**Freightliner
Service Bulletin**

General Information

Fill Neck Replacement

Fig. 1, Magnetized Fill Neck

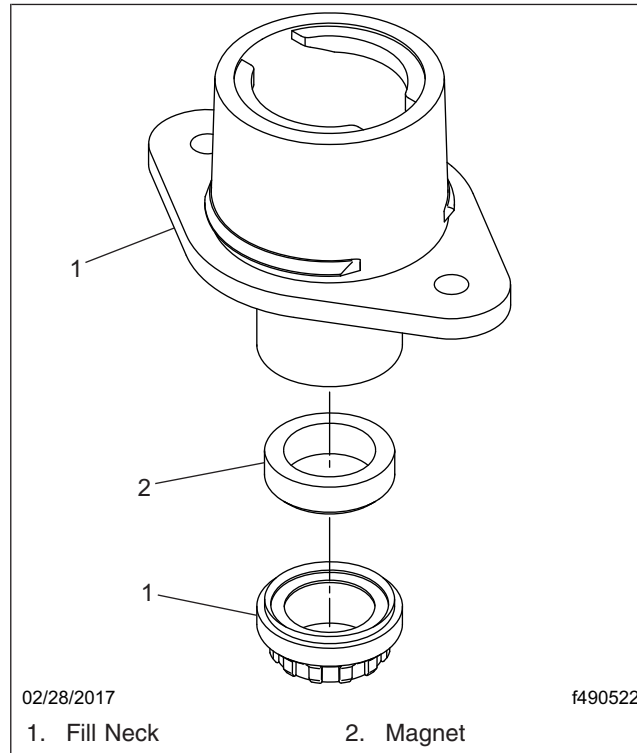
In June 2016, a design change removed the magnets from the fill necks for some 6 gallon DEF tanks. Due to some customer's needs for a magnetized filler neck, a fill neck with an incorporated magnet (04-32529-001) is now offered, and can be retrofitted. See [Fig. 1](#).

Fig. 2, Filler Neck Installation

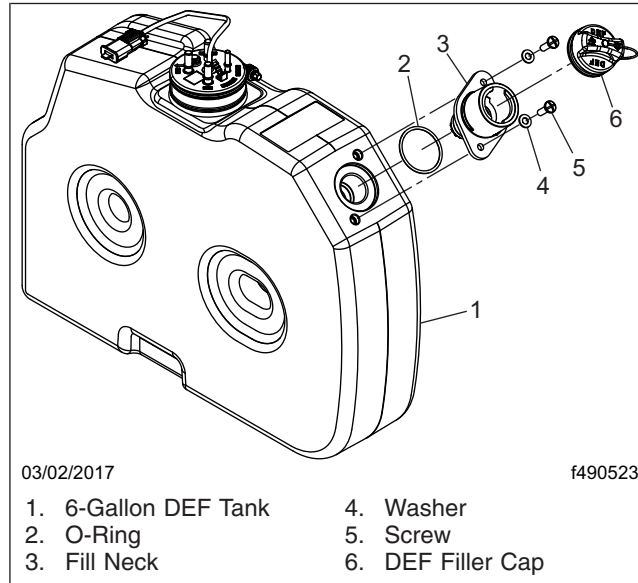
Refer to [Fig. 2](#) for this procedure.

1. Park the vehicle on a level surface, shut down the engine, and set the parking brake. Chock the tires.
2. Remove the screws and washers.
3. Lift off the old filler neck, and discard.
4. Install the O-ring on the new filler neck.
5. Position the new filler neck (with the incorporated magnet) on the DEF tank.

The tank has captured nuts incorporated for attaching the filler neck. Over tightening the fasteners may damage the tank and require replacing it.

6. Install the screws and washers. Tighten the screws 48 lbf·in (540 N·cm). Do not over tighten.
